UNITED STATES PATENT AND TRADEMARK OFFICE

APPLICATION NO.	FILING DATE	FIRST NAMED INVENTOR	ATTORNEY DOCKET NO.	CONFIRMATION NO.
10/711,533	09/24/2004	Jing-Horng Gau	13791-US-PA	5532
31561	7590	12/05/2005	EXAMINER	
JIANQ CHYUN INTELLECTUAL PROPERTY OFFICE			TOBERGTE, NICHOLAS J	
7 FLOOR-1, NO. 100			ART UNIT	PAPER NUMBER
ROOSEVELT ROAD, SECTION 2			2823	
TAIPEI, 100				
TAIWAN

Office Action Summary	Application No.	Applicant(s)
	10/711,533	GAU, JING-HORNG
	Examiner	Art Unit
	Nicholas J. Tobergte	2823

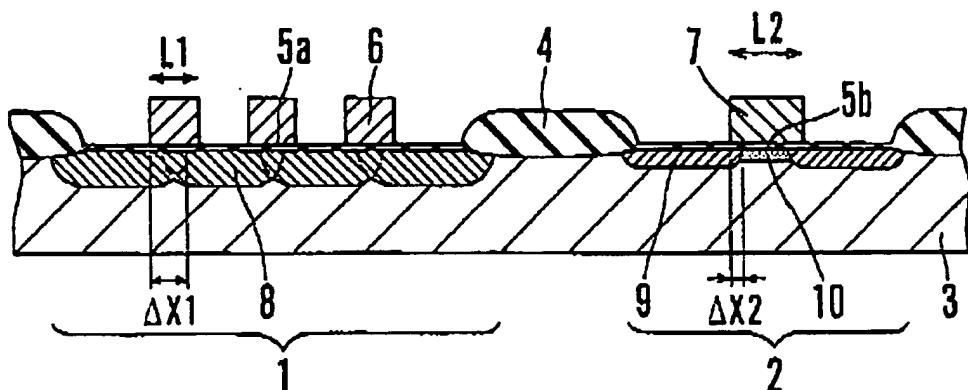
Pertaining to claim 1, Kasai teaches a method of fabricating a capacitor, comprising:

Forming a dielectric layer 5a on a semiconductor substrate 3;

Forming an upper electrode 6 on the dielectric layer 5a, the upper electrode having a plurality of opening therein **See Fig 7D**; and

Performing a doping step to the substrate through the openings to form a single doped region 15 as a lower electrode 8 in the substrate 3 under the upper electrode 6
See Fig 7D.

Pertaining to claim 5, Kasai teaches the method of claim 1, wherein the upper electrode includes a plurality of bar-like conductive layers connecting with each other, and the openings in the upper electrode are trench-like openings between the bar-like conductive layers. **See Fig 7D**
